Re: Consultation on an Application

Application No: 191848

Address: Greyfriars Church, Greyfriars Road, Reading

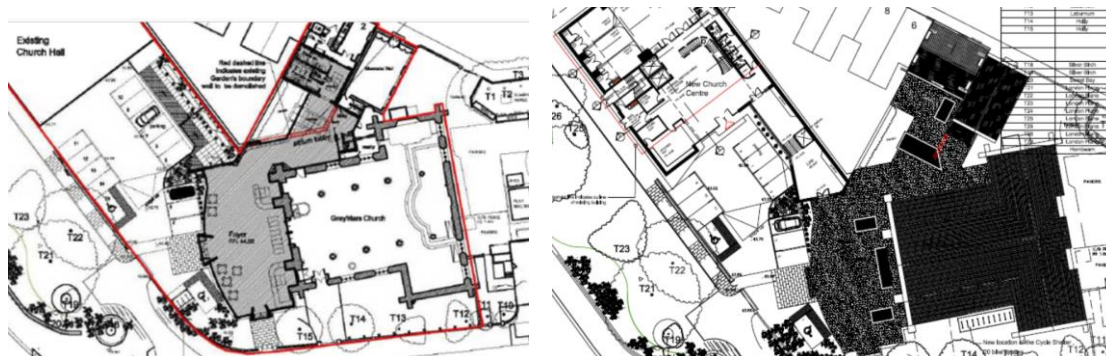
The removal of several trees (T16 & T17) was agreed under 190650 on the basis that space was available within landscape beds for new tree (and other) planting; a condition attached to secure these details. The proposed site layout under this current application results in less space for landscaping, specifically due to the link structure. A comparison can be seen below; approved left, proposed right:
